**US 97 Bend North Corridor Project
Deschutes County, Oregon
Federal-Aid Number S004(112)
ODOT Key Number 14020**

September 2014

1. DECISION

Exhibit 3-54: Emergency Service Provider Estimated Response Times from the Public Safety Complex

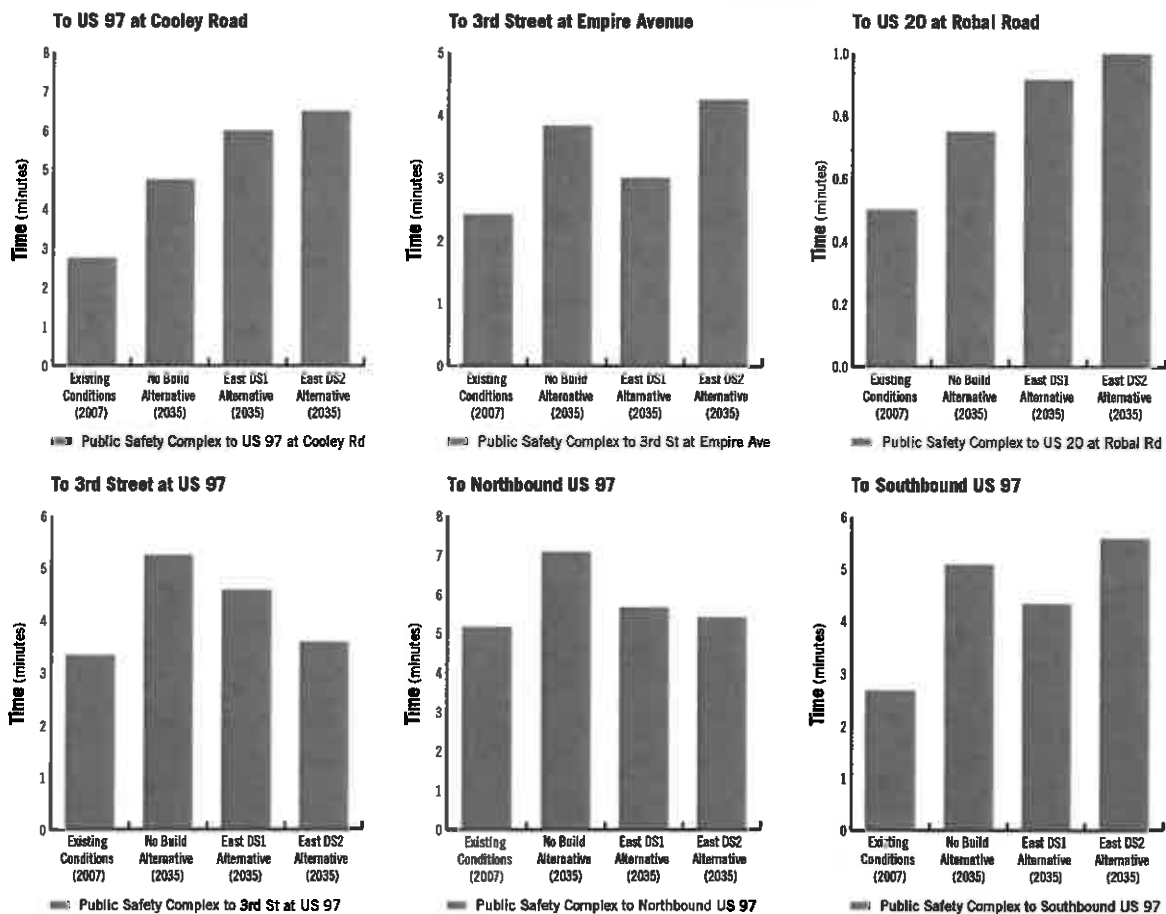
3-169 Replaced the bar graphs in Exhibit 3-54 with the versions presented in the Draft EIS, which include data for the East DS2 Alternative rather than the East DS2 Modified Alternative:
